# MetroNews

Tuesday June 26, 2007

## Shake-Tile 'V'-Batten Riser Metal flashing

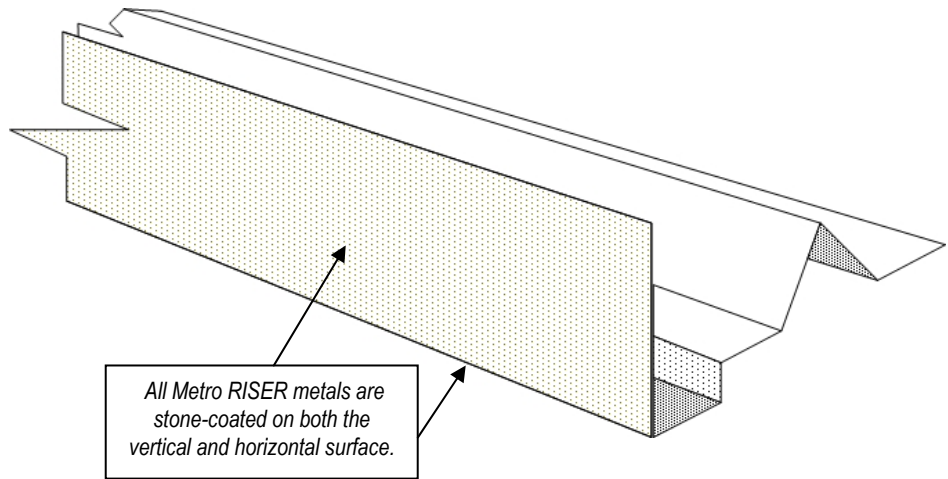
Our Shake-Tile Riser metal flashing has been upgraded to the new 'Shake-Tile V-Bat Riser metal', incorporating a panel support V-Batten that eliminates the need for a costly 1X4 wood batten to be used across the fascia-eave to support the panel.

This new part eliminates the need for the fascia support batten and the labor to install it. The new Shake-Tile V-Bat Riser Metal can now be installed after perimeter flashing & underlay inspections, prior to panel install. The new 'Shake-Tile V-Bat Riser Metal' flashing in standard stone-coat colors will be in production during June-July 2007.

ITEM X LENGTH	PN-# - XX = Color	INVOICE INFO
Existing Shake-Tile Riser Metal Flashing X 79"	3133-XX	
<b>NEW 'Shake-Tile V-Bat Riser Metal' Flashing X 79"</b>	<b>3132-XX</b>	<b>'Shake-Tile V-Bat Riser'</b>
